CITY OF PORTLAND, MAINE

AGENDA PORTLAND PLANNING BOARD MEETING

Memorandum

Hammond House, LLC has submitted a Major Site Plan and Subdivision application to facilitate the development of a 48 unit Planned Residential Unit Development (PRUD), along with associated site improvements, at o Dalton Street (located between Sherwood and Dalton streets), to be known as Winchester Woods. This project will combine 16 existing parcels into one parcel on which to site four 34' in height identical structures under a PRUD model. The site will be accessed through an existing right-of-way via Sherwood Street, with additional partial access to a recreation space and a walking trail at the end of Dalton Street. An existing single-family home, which is under common ownership with this development, will be renovated and split off from the PRUD as its own parcel. The subject parcels total 3.4 acres in size and are zoned R-5 Residential.

Figure 5 – Landscaping Plan

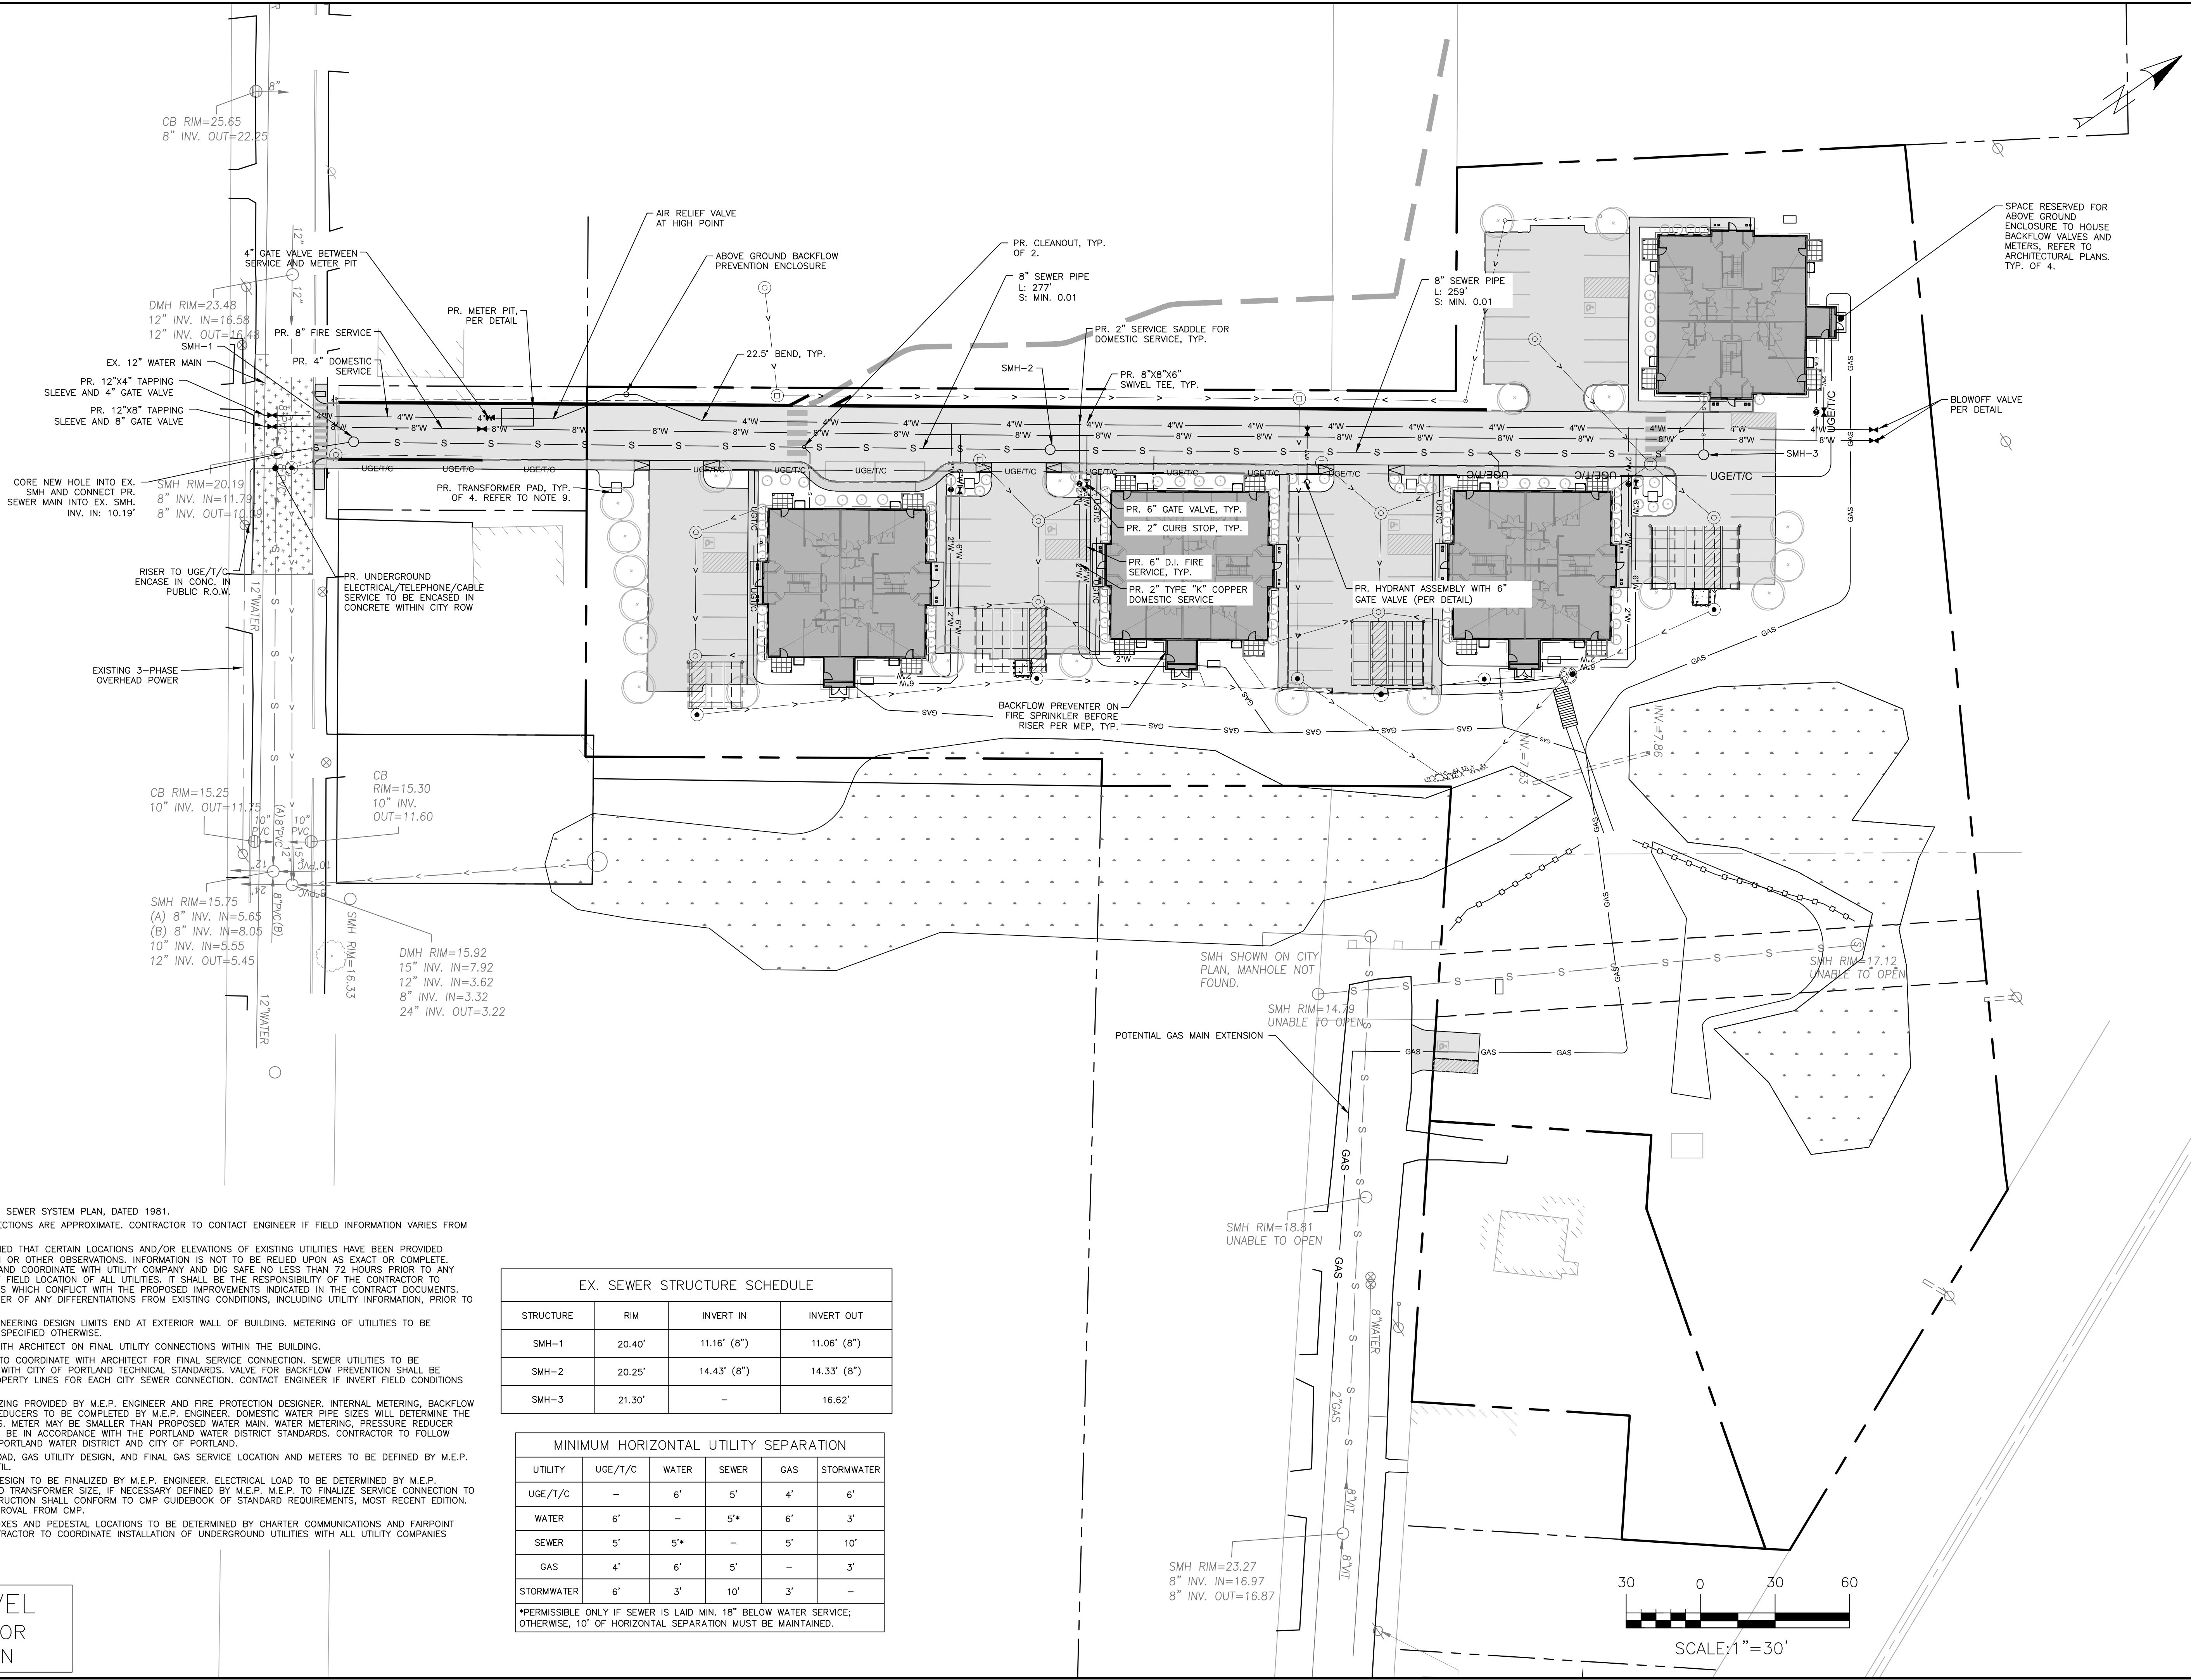
The street tree requirement for PRUDs is two trees per unit in or near the ROW. The applicant is proposing 48 residential units, therefore will need 96 trees on the entire site. In reviewing the site plan, there are only six trees that will qualify as street trees. The applicant will need to work with the City Arborist to determine

where more street trees can be planted. A landscaping plan needs to be submitted that shows the preservation of existing trees and street trees on site.
